APPROVED AS NOTED

USAID-306-C-00-10-00501-00
ISLAMIC REPUBLIC OF AFGHANISTAN
MINISTRY OF HIGHER EDUCATIONS
RENOVATION OF BOTANY DEPARTMENT, KABUL UNIVERSITY
KABUL, AFGHANISTAN
BUILDING # 28
ROOF BEAM (13) TO (18) AND METAL PANEL CONNECTION DETAIL

SHEET REFERENCE NUMBER:
28-SD04
Sheet 04 of --

1 (28-SD04) ROOF BEAM (13) TO(18) SECTION (Typ.)
SCALE: 1:10

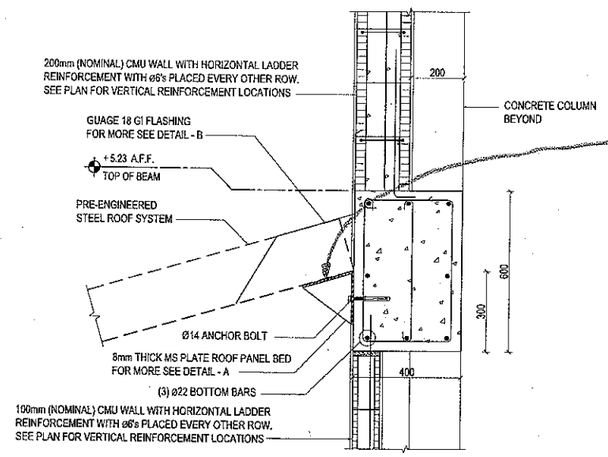
SHOW CONNECTION OF ROOF PANEL TO BENT PLATE.

VERIFY BENT PL. IS CONTINUOUS.

A (28-SD04) DETAIL
SCALE: 1:2

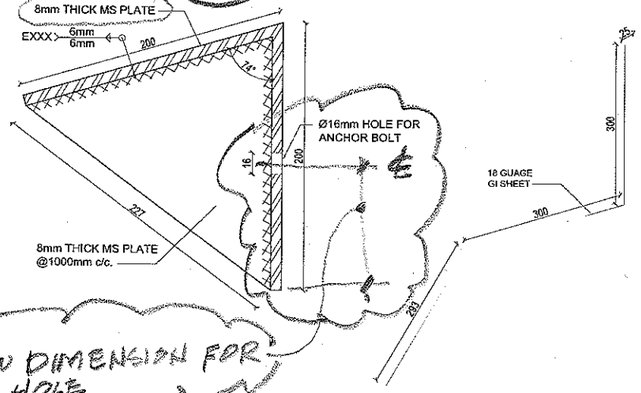
SHOW DIMENSION FOR BOLT HOLE

2 (28-SD04) ROOF PANEL BED ISOMETRIC VIEW
SCALE: 1:5

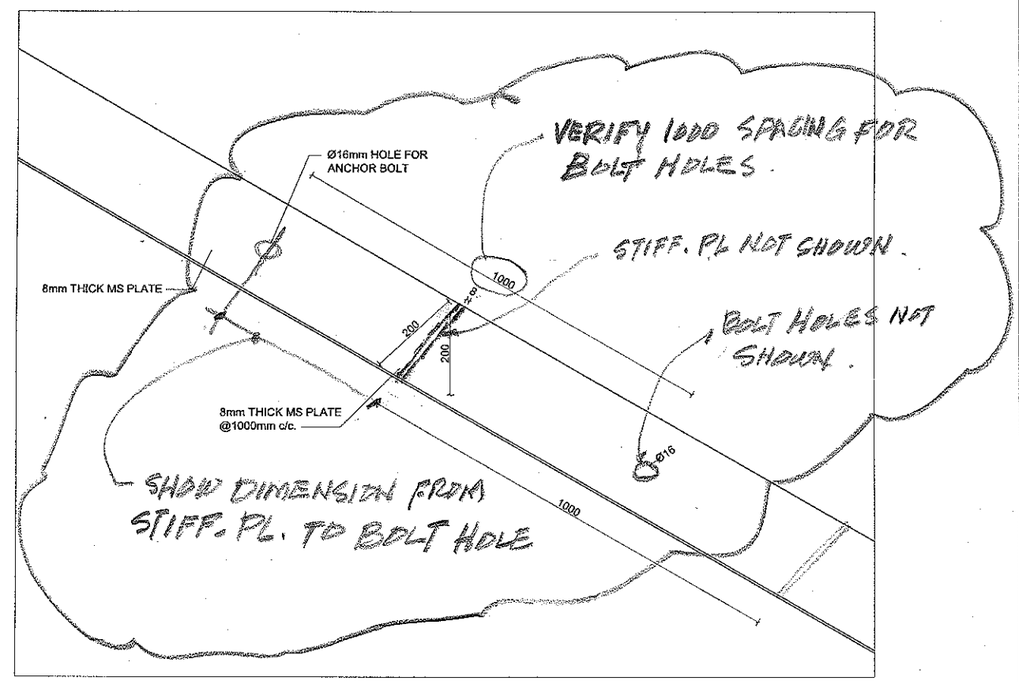
VERIFY 1000 SPACING FOR BOLT HOLES.

STIFF. PL NOT SHOWN.

BOLT HOLES NOT SHOWN.

SHOW DIMENSION FROM STIFF. PL. TO BOLT HOLE
